GOVERNMENT OF THE DISTRICT OF COLUMBIA  
DEPARTMENT OF TRANSPORTATION

**MEMORANDUM**

**SUBJECT:** ZC Case No. 17-09 – 1501 Harry Thomas Way NE (Eckington Park)

Figure 1 – Ground Floor and Circulation Plan (Source: CTR, Gorove/Slade, Figure 6, 10/19/17)

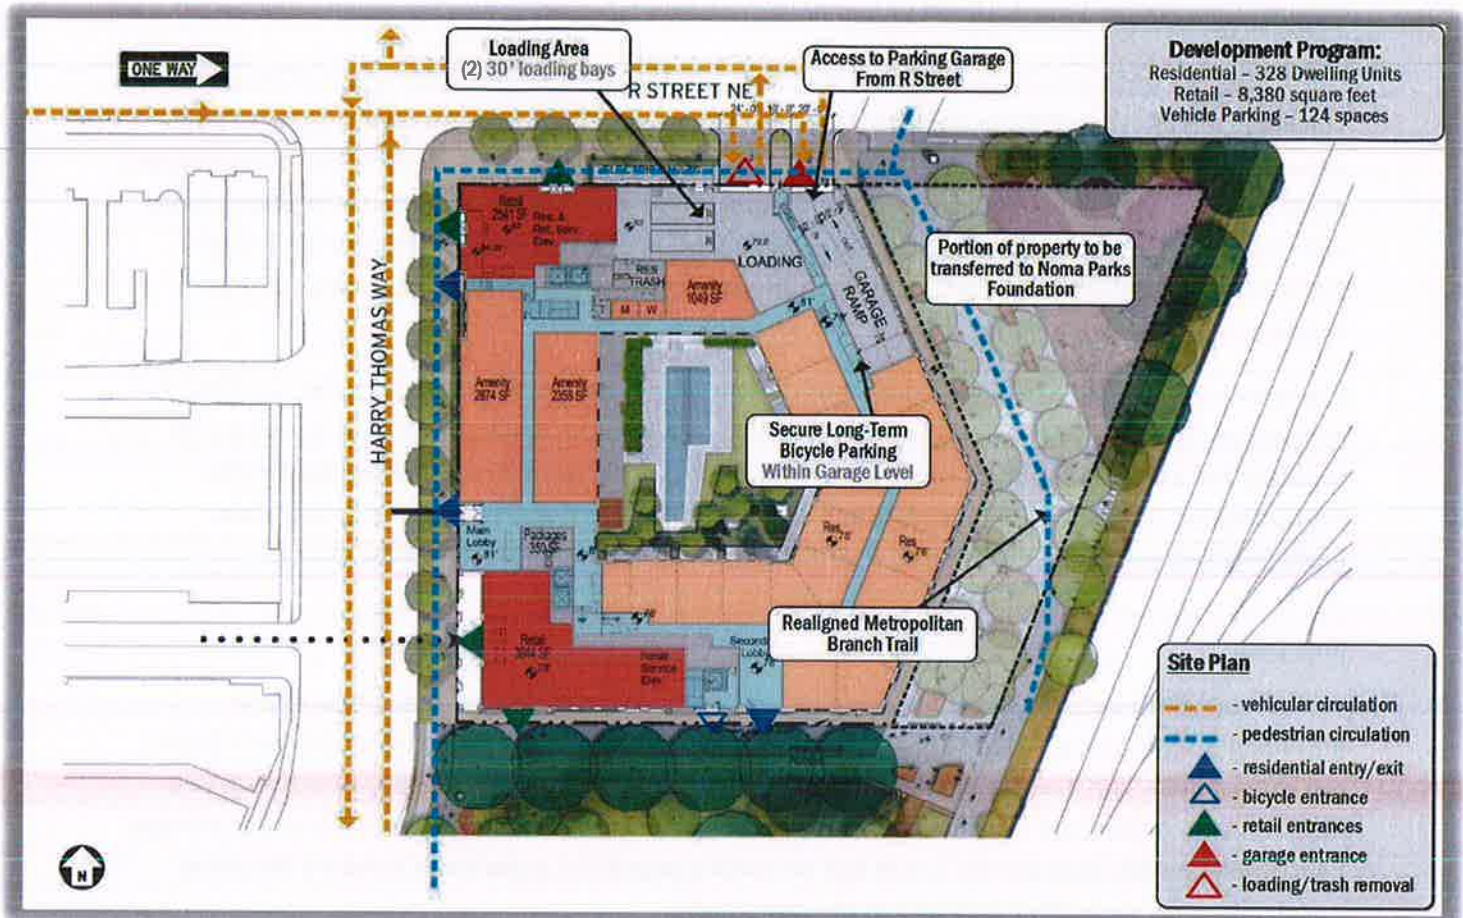
- The Applicant proposes to construct a sidewalk on the southern side of R Street NE along the northern edge of the property that terminates just before the Metropolitan Branch Trail. The Applicant should update the drawings to show the sidewalk connecting to the Trail;

loading activity anticipated, DDOT is in concurrence with the proposed loading scheme as shown in Figure 1 above.
